HOWDY COURT ENTRANCE SIGN

- After review of the Oct 4th e-mail from Cody Cravatt and subsequent discussions with Martin Zimmerman, we accept all revisions to the narrative description of this revision and will comply fully with the insurance requirements set forth by the City. We will provide engineer stamped drawings when we pursue the actual sign permit.

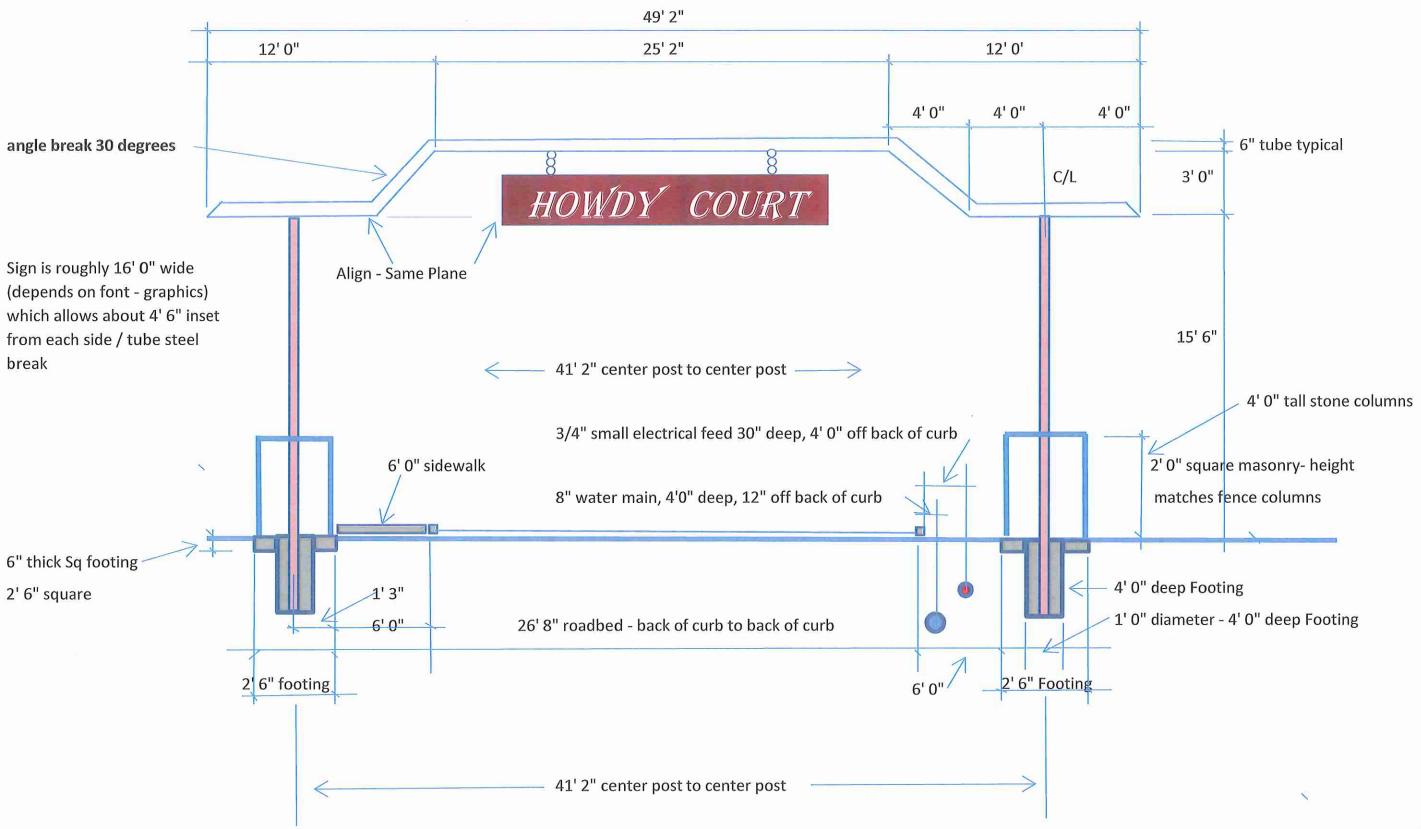
- Referring to Sketch "A", the sanitary system flows west and north to a manhole north of the property. The service for the far east houses stops about 25 feet from the proposed overhead sign. Therefore, the sanitary system is nowhere close to the sign and/or any possible conflict. Sketch "B" is an enlarged clarification

- Sketch "C" indicates the main water service to the subdivision come from across Old College, from the east side. The 8" water main runs immediately outside the curb along the north side of Howdy Court. So this center line is approximately 1' 0" from the back of curb. The center of our proposed sign footing is 7' 0" from back of curb. The footing is 2' 0" square so will range from 6' 0" to 8' 0" from back of curb. This allows 6' 0" of grass surface to service the water main if necessary.

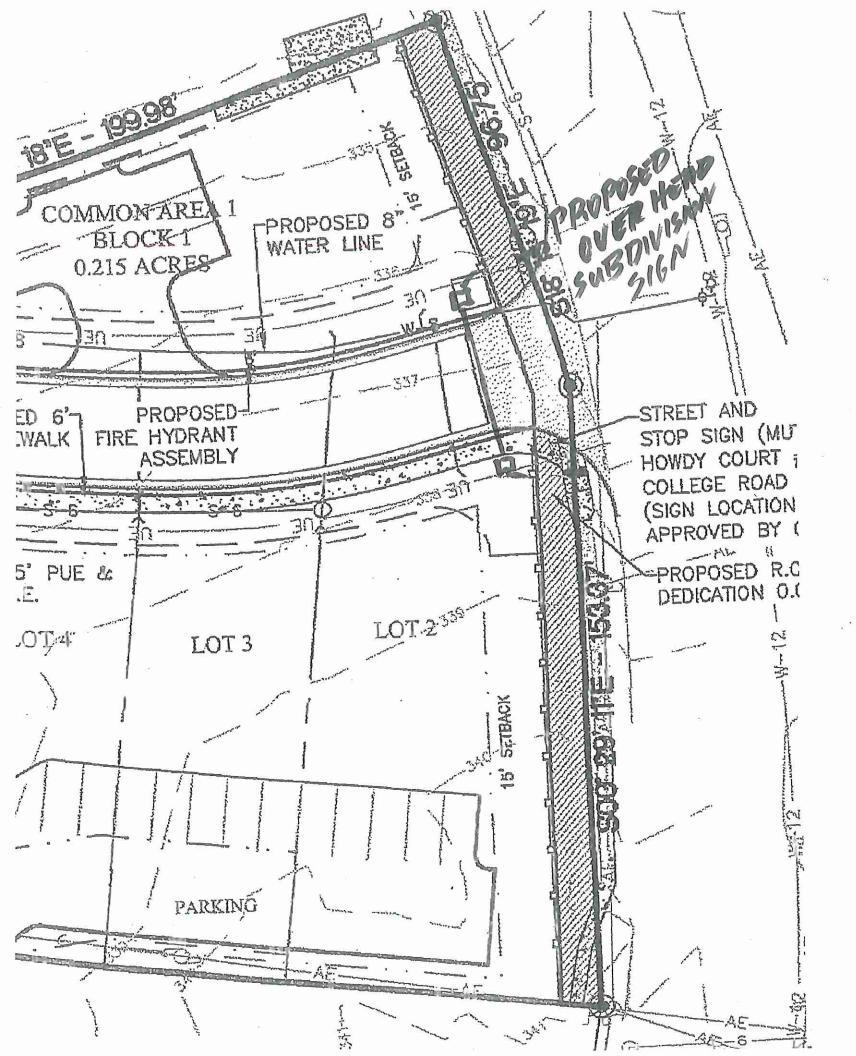
- Sketch "D" is the actual BTU as built drawing that shows the main loop of electrical service fed from the southwest corner. The transformers and secondary pedestals for the two eastern most house (close to the gate) are approximately 25' from the gate. So there is no conflict with the high voltage service, transformers and/or pedestals whatsoever.

- However, Sketch "D" also show a small secondary feed, in a 3/4" conduit, that runs from the northeastern most transformer to the street light on the northeast corner of Old College and Howdy Court. This line is approximately 4' 0" off the back of curb. The center of our proposed sign footing is 7' 0" from back of curb. The footing is 2' 0" square so will range from 6' 0" to 8' 0" from back of curb. This allows 6' 0" of grass surface to service this small feeder if necessary.
